Tulsa Metropolitan Area Planning Commission

Project Anthem

Preliminary plat approval for Project Anthem.

The plat consists of 1 lot, 1 block, ±339.11 acres. Staff recommends **approval** of the preliminary subdivision plat subject to the following conditions provided by the Technical Advisory Committee (TAC) and all other requirements of the Subdivisions Regulations. A City of Tulsa release letter is required prior to final plat approval. TAC Conditions:

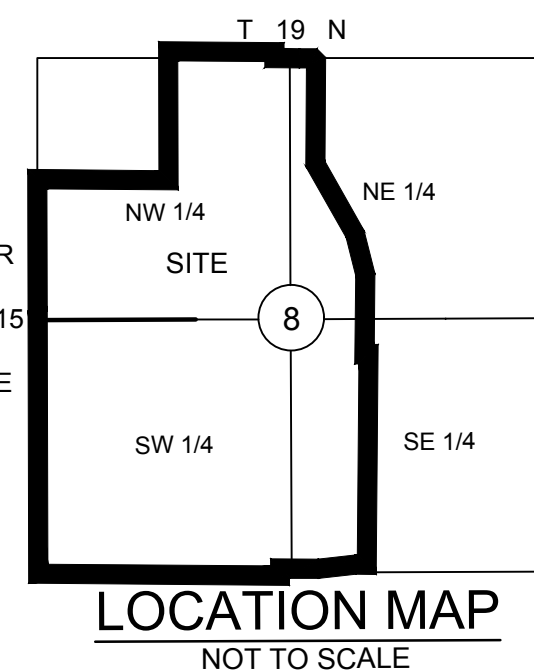
- Submit subdivision control data sheet with the final plat.
- Remove contours on final plat submittal.
- In the plat subtitle add "State of" before Oklahoma.

- Provide the mailing address under the Owner information.
- Provide an engineer and surveyor heading/section that has the name of the business, mailing address, name of the engineer/surveyor, CA number with expiration date, phone number, and email address.

- Provide the individual lot addresses on the face of the plat.
- Consider having a Subdivision section that list out acreage, square feet, zoning, number of lots, number of blocks, reserve areas, etc.

- In the Location Map show the Creek Turnpike and label the section line streets on the perimeter of the section. Those being E 11th St S, E 21st St S, S 193rd E Ave, and S 225th E Ave. Label all other land in the section as "unplatted".

- Provide graphically on the face of the plat the address disclaimer/caveat.
- Provide the date of preparation on the face of the plat. Typically this is shown at the lower right-hand corner of the page.

- Under the Basis of Bearings information include the coordinate system used. Provide a bearing angle preferably shown on the face of the plat. See example below.

- Add signature block for officials to sign to the face of the plat.
- Provide on the face of the plat the last date of survey site visit. If this was a range of dates provide those.
- There are several hatch patterns used on the north end of the plat. Add to the legend.

- Future development will require detention, other mitigation runoff, or approved recommendation for Fee-in-lieu-of detention. Multiple proposed detention easements appear to be shown on the face of plat without callouts or labelling. The outlet structures from the ponds should not be in the detention easements, as those outlet pipe structures will be privately held.

- I do not see any perimeter easements displayed on the plat, those will need to be referenced if dedicated by separate instrument.
- Per NFIP CRS requirements, plot boundary of floodplain on face of plat to show it is contained within the OD/E.

- Southeast corner – Clarify “Find” or “Found” for the described aluminum monumentation.
- Any offsite easements to cover public infrastructure extensions required by this project will need to be filed and the recording information shown on the face of the plat prior to filing the plat.

- Recording information for all easements “By Separate Instrument” that contain public infrastructure will need to be included on the final plat.
- Many easements that do not specify what kind of easement. Please clarify.

- Easements that are created via this plat need to have dimensions.
- Provide metes and bounds for ROW dedication where it is not parallel to existing ROW and can be described with a simple dimension.

- It appears that ROW is to be dedicated on the south side, along E. 21st Street. Clearly dimension the proposed ROW dedication.
- Statutory ROW call outs should be based on section line, not total ROW.
